**ZONING AMENDMENT &
PLANNED UNIT DEVELOPMENT
STAFF REPORT**

Date: April 4, 2013

<u>NAME</u>	DIP Exchange, LLC
<u>DEVELOPMENT NAME</u>	DIP Exchange, LLC
<u>LOCATION</u>	93 Sidney Phillips Drive (West side of Sidney Phillips Drive, 190'± South of Old Shell Road).
<u>CITY COUNCIL DISTRICT</u>	District 1
<u>PRESENT ZONING</u>	B-3, Community Business, and I-1, Light Industry
<u>PROPOSED ZONING</u>	I-1, Light Industry
<u>REASON FOR REZONING</u>	To eliminate split zoning.
<u>AREA OF PROPERTY</u>	1 Lot / 3.6± Acres
<u>CONTEMPLATED USE</u>	<p>Planned Unit Development Approval to allow reduced front landscaping requirements and multiple buildings on a single building site, and Rezoning from B-3, Community Business District, and I-1, Light Industry District, to I-1, Light Industry District, to eliminate split zoning.</p> <p>It should be noted, however, that any use permitted in the proposed district would be allowed at this location if the zoning is changed. Furthermore, the Planning Commission may consider zoning classifications other than that sought by the applicant for this property.</p>

SITE PLAN

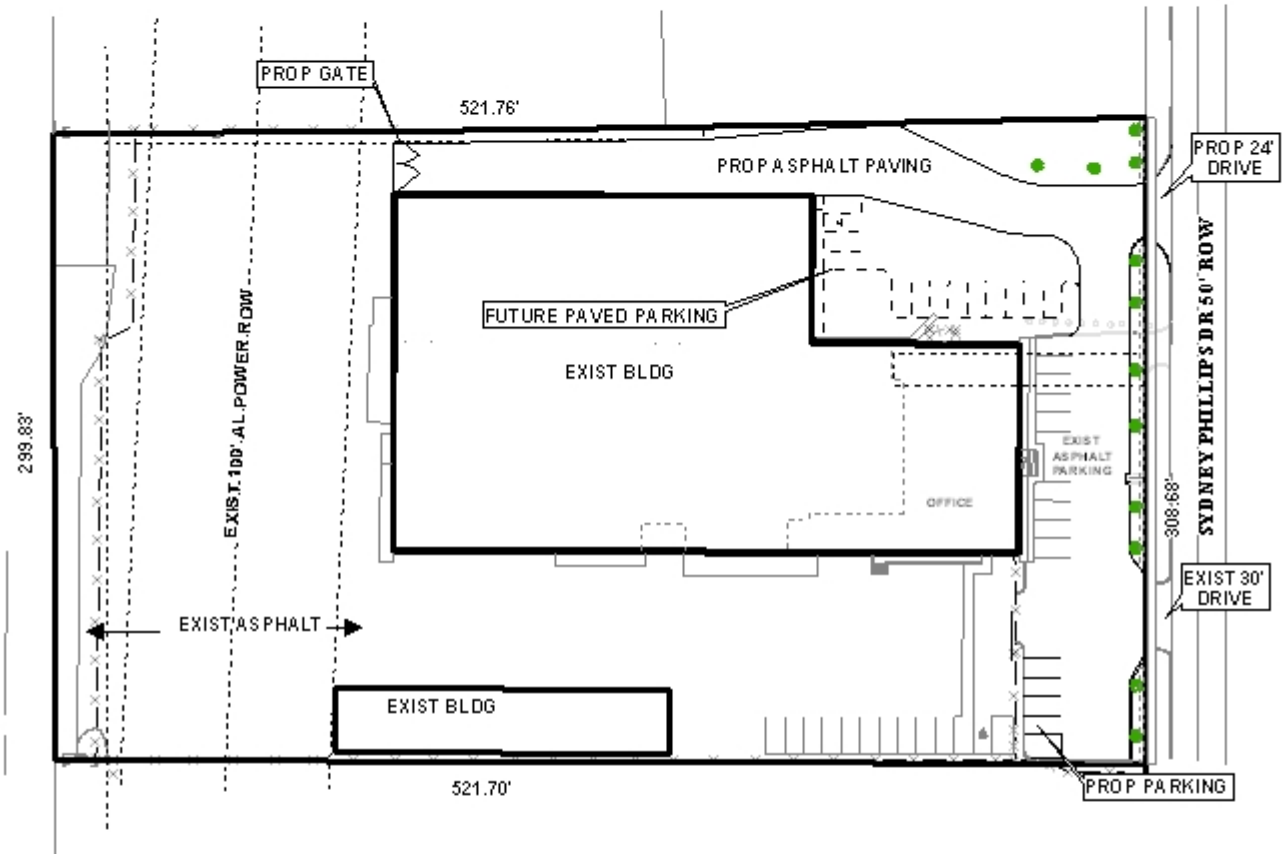
The existing buildings meet the standard 25' front setback, but as there were no landscaping and tree planting requirements when the site was developed, no allowance for such was made in the front yard and parking was provided in that area. With the parking and access modifications, 13 parking spaces are proposed in the front and 11 are proposed along the South side in the side yard. However, the 6680 square-foot office will require 23 parking spaces instead of the 22 calculated on the site plan, and 2 warehouse employee spaces are calculated. Therefore, as 25

parking spaces are required, and 24 are proposed, the site plan should be revised to furnish one additional parking space.

The applicant proposes to retain the Southern-most drive to the site, close the drive at the middle of the site in the front parking area, and add a new drive and curb cut at the North end of the site. That new drive would provide access to the existing front parking area and to a proposed drive to the rear of the site along the North side of the building. It would also provide access to a proposed future parking area adjacent to the North side of the existing front parking area. Since that is proposed as a future development, a revised ADMIN PUD would be required prior to development of that portion of the site.

The site plan indicates a dumpster in the rear yard, but no compliance information is provided. Therefore, the site plan should be revised to indicate a fully compliant dumpster and pad. Also, there is a 100' wide Alabama Power Company right-of-way crossing the rear portion of the site; therefore, a note should be placed on the site plan stating that no structure may be erected within that right-of-way without a recorded agreement with Alabama Power Company. There is also a 25' drainage easement along the rear of the site; therefore, a note should be placed on the site plan stating that no structure may be erected within that easement. As the existing 30' by 60' building along the South side of the property was built with the 1970's development of the site and does not meet the required zero or 5'+ setback requirements for I-1, a note should be placed on the site plan stating that any expansion of that building must meet the required side yard setback for I-1 districts.

The site requires 11,391 square feet of frontage landscaping and 3,592 square feet are provided. The front yard currently is 60' deep, and an area cumulatively totaling approximately 190' linear feet of the front yard would have to be landscaped to meet the requirement. This would completely eliminate the parking area directly in front of the building and the associated cross-access in order to retain the two drives and front parking in the South portion of the front yard. As the site was developed prior to the enactment of the landscaping requirements, and as meeting the front landscaping requirement (and total landscaping requirement of 18,987 square feet, with 20,091 provided) would drastically reduce the viability of the site's access and traffic pattern, it would stand that adhering to the requirements would be counter-productive to the upgrading of the site.

- 3) revision of the parking calculations to provide 23 spaces for the 6,680 square-foot office, with a total of 25 parking spaces required;
- 4) submittal of a revised PUD prior to the development of the future parking area on the North side of the building;

- 5) revision of the site plan to provide a fully compliant dumpster and pad;
- 6) placement of a note on the site plan stating that no structures may be erected within the 100' Alabama Power Company right-of-way, or within the 25' drainage easement;

- 7) placement of a note on the site plan stating that any future expansion of the existing 160' by 30' building on the South side of the site must comply with the zero or 5'± side yard setback requirements for I-1 districts;

- 8) the provision of ten (10) frontage Live Oak trees; and
- 9) the furnishing of two (2) copies of a revised site plan to Planning indicating compliance with the above conditions.
